December 17, 2004
NRC:04:072

**Response to a Request for Additional Information regarding EMF-2103(P) Revision 1,
"Realistic Large Break LOCA Methodology for Pressurized Water Reactors"**

Framatome ANP requested NRC review and approval of the topical report EMF-2103(P) Revision 1, "Realistic Large Break LOCA Methodology for Pressurized Water Reactors," in Reference 1. A request for additional information was provided by the NRC in an e-mail on November 4, 2004. The questions and responses are provided in Attachment A to this letter.

Figure 1 Containment Volume Sampling Scatter Plot for 3-Loop Sample Problem

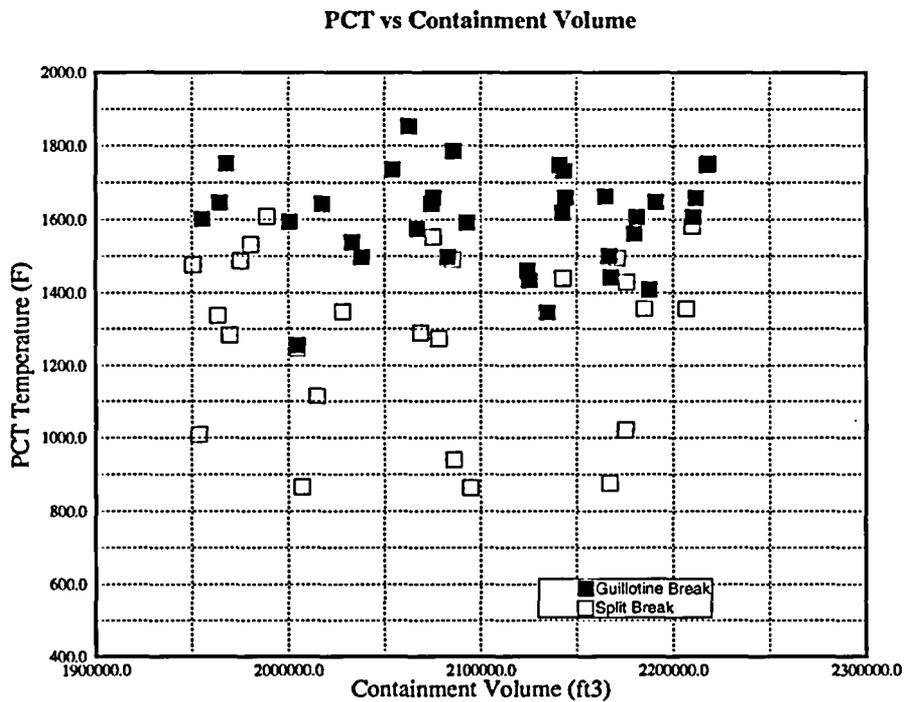
Question 1: Provide the following scatter plots of operational parameters (similar to those provided in Appendix D of EMF-2103(P) Revision 0) for the reference case:

- (a) containment volume
- (b) containment gas temperature

Appendix H should be revised to include this information.

Response 1: The requested information is provided in Figures 1 and 2. These figures will be added to Appendix H, or, alternatively, with the similar figures appearing in Appendix D, when the approved version of EMF-2103 Revision 1 is issued. Statements referring to these figures and recognizing the absence of any observable correlation to PCT will be added to section H.2.3.

Figure 3 Containment Volume Sampling Scatter Plot for 4-Loop Sample Problem

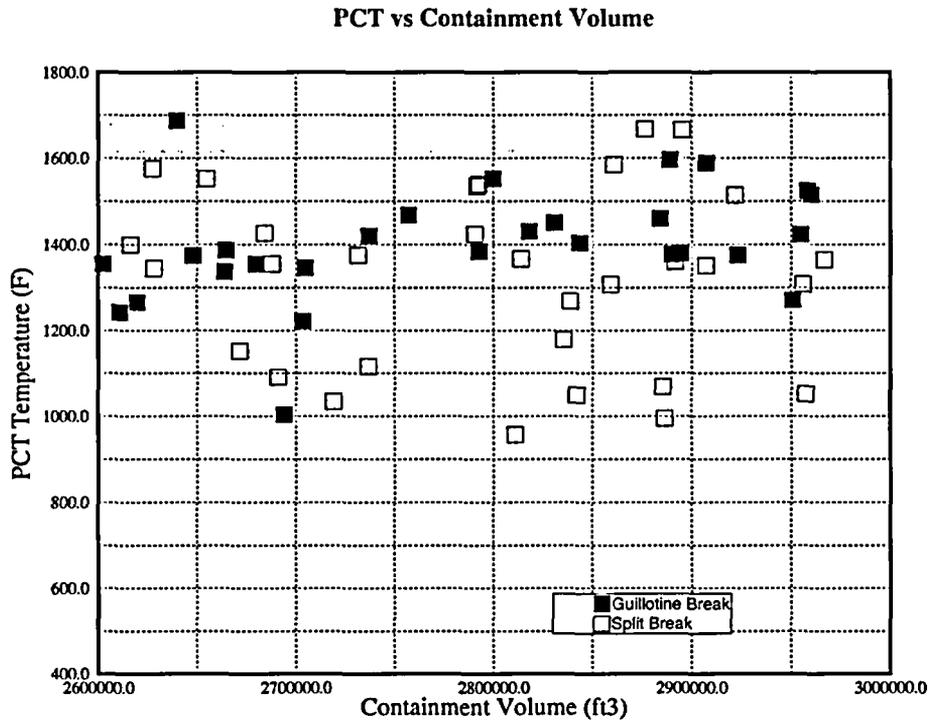
Question 2: Provide the following PCT scatter plots of operational parameters (similar to those provide in Section 5 of EMF-2103(P) Revision 0) for the reference case:

- (a) containment volume
- (b) containment gas temperature

Appendix H should be revised to include this information

Response 2: The requested information is provided in Figures 3 and 4. These figures will be added to Appendix H or, alternatively, with the similar figures appearing in Section 5, when the approved version of EMF-2103 Revision 1 is issued. Statements referring to these figures and recognizing the absence of any observable correlation to PCT will be added to section H.2.3.
